**Flood Control Project Maintenance
Levee Inspections**

2018 Channel Summary Report

Tehama County Fld Control & Water Cons Dist

Levee Inspection Report By Mile - Channel 2018

Photo 1 of 1 : CH_2018_NA0019_4_1_20180625_00007.jpg

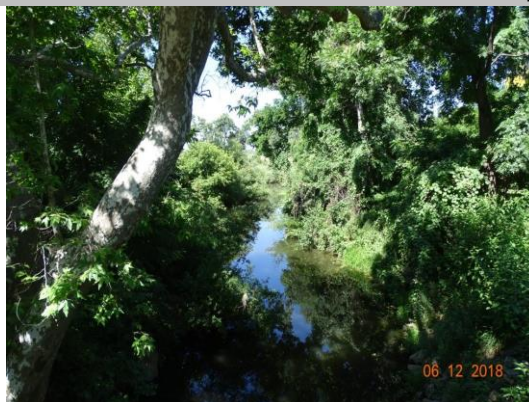
Rating **	A	Issue No.	1	GPS Lat/Long
Issue Type +	Ma	Location *		40.157120 °
Category	Rivers, Channels & Designated Flood			-122.164250 °
Item	Vegetation & Obstructions			
DWR ID	DWR_NA0019_4_c_2012_1			
Action/Comments				
Inspector Comments: Minimal, scattered obstructions or vegetation. The flow is not impeded.

Upstream view of Salt Creek from the railroad car bridge.
